**Licence Number** L7178/1997/11

**Licence Holder** Dampier Salt Limited

**Premises** Dampier Salt – Lake MacLeod  
AML 70/245, L09/10, L09/11, L09/17 and L09/18  
Blowholes Road  
CARNARVON WA 6701

**Date of Amendment** 20 March 2018

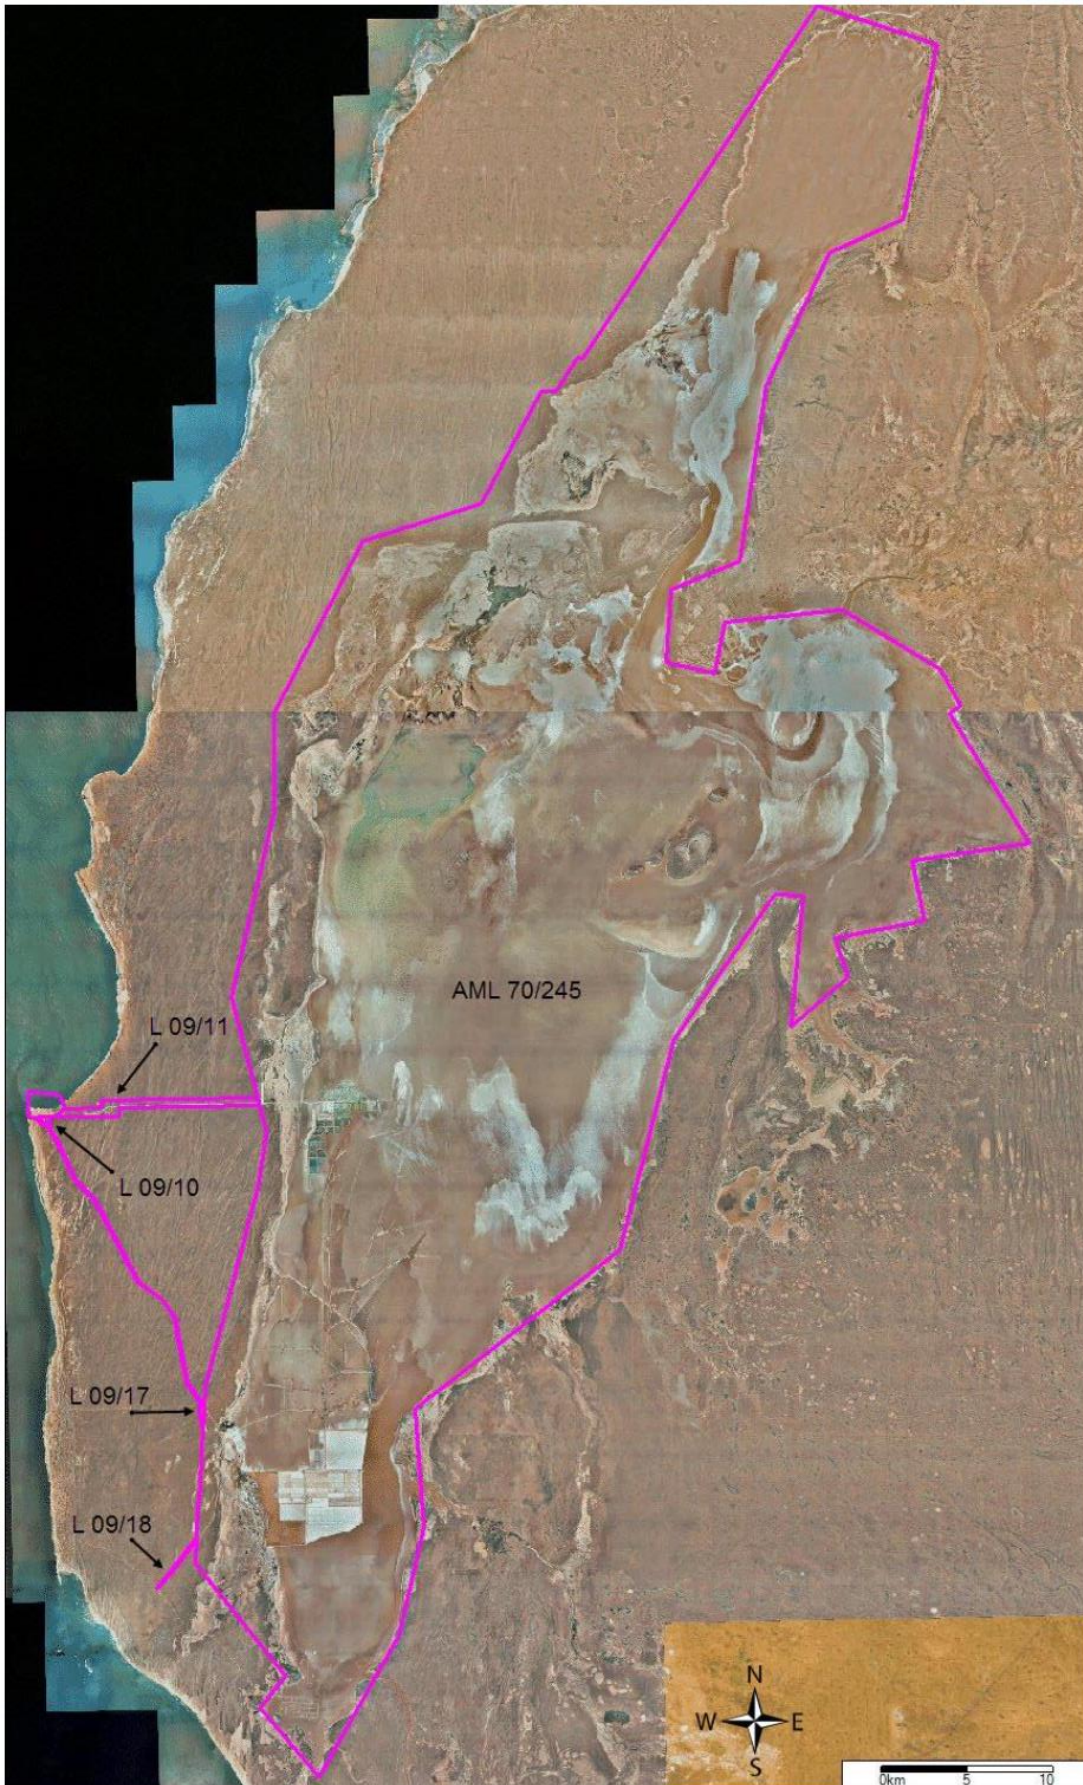
7. Condition 4.2.1 of the Licence is amended by the insertion of the red text shown in underline below:

4.2.1 The Licensee shall submit to the CEO an Annual Environmental Report within 120 calendar days after the end of the annual period. The report shall contain the

information listed in Table 4.2.1 in the format or form specified in that table.

<b>Table 4.2.1: Annual Environmental Report</b>		
<b>Condition or table (if relevant)</b>	<b>Parameter</b>	<b>Format or form1</b>
-	Summary of any failure or malfunction of any pollution control equipment and any environmental incidents that have occurred during the annual period and any action taken	None specified
Table 3.2.1	Discharge to water monitoring results	
Table 3.3.1	Discharge to land monitoring results	
<a href="#"><u>3.4.2</u></a>	<a href="#"><u>Acid Sulfate Soil investigation data and management actions required by Condition 3.4.1</u></a>	<a href="#"><u>Presented in the format shown in Schedule 3 (Table S-3)</u></a>
4.1.3	Compliance	Annual Audit Compliance Report (AACR)
4.1.4	Complaints summary	None specified
